TRANSMITTAL OF OPERABLE UNIT (OU) 9 TECHNICAL MEMORANDUM NO. 1, VOLUME 1, DRAFT FINAL MODIFICATION FOR TANK SITES T-11 AND T-30 - CDC-017-94

REVIEW COMMENT RECORD

Document Reviewed: OU9 Technical Memorandum I, Volume I T-11 and T-30		Reviewer: J.R. Burd Signature: Date: Oct. 31, 1994 Phone: x8252 Organization: ER/RFO		Agreement with Dispositions: Date: Reviewer: Document Preparer:	
*Comment Type: E = Essential (agreement must be documented for other than verbatim incorporation); S = Suggested; Non-C = Nonconcurrency

FIGURE 3-4a
SAMPLE LOCATIONS
FOR T-11 AND T-30
Operable Unit 9
Original Process Waste Lines

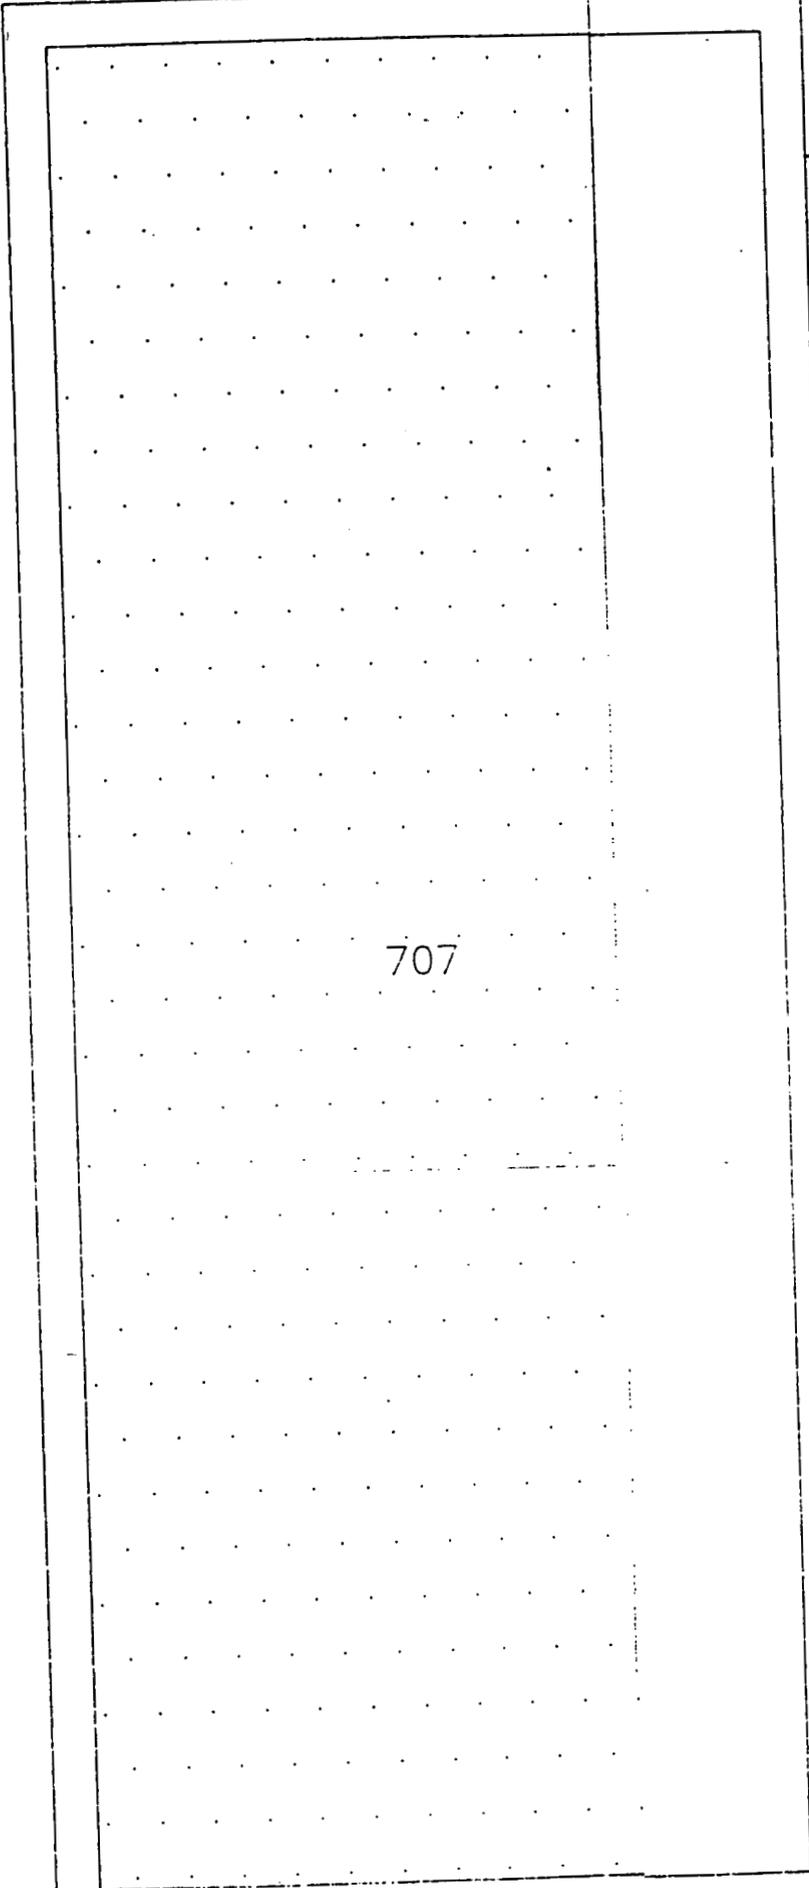
Comment No.	Comment Type*	Para. No.	Comment	Disposition	
4	S	3.2.6	<p>The 2nd sentence in the last paragraph should be reworded to, "Groundwater samples will also be analyzed for tritium".</p> <p>The 3rd sentence in this paragraph should have "for all samples" inserted after "analysis" if this is true. This sentence should also be specific about which media will be analyzed for special parameters such as groundwater for specific conductivity.</p>	<p>The sentence was changed to "Groundwater samples will also be analyzed for tritium".</p> <p>The sentence was changed to include "for all samples" inserted after "analysis". The phrase "for groundwater samples" was inserted after parameters.</p>	
5	E	App A	<p>2nd column, point 2. - The reference to the surface soil sample should be removed if this sample is deleted.</p> <p>3rd column, point 2. - Will the HPGe survey be conducted on a 4-foot grid? If so will the configuration be modified to eliminate the serious over sampling that will otherwise occur?</p> <p>3rd column, point 4. - This point says that one wipe sample will be collected for the inside of the tank. The text says that a wipe sample will be collected from the sump.</p> <p>3rd column, point 5 - Refer to comments on the surface soil sample. Delete from this point if this sample is not taken.</p>	<p>Sample was not deleted, see response to comment number 3.</p> <p>The 4-foot grid refers to the NaI survey only. The text was changed to "The NaI survey will be conducted using 4-foot grids and will cover the entire area of T-11, T-30 to delineate source."</p> <p>The sentence was changed to "in instances where no residue is present, one wipe sample will be collected from the vault area".</p> <p>Sample was not deleted, see response to comment number 3.</p>
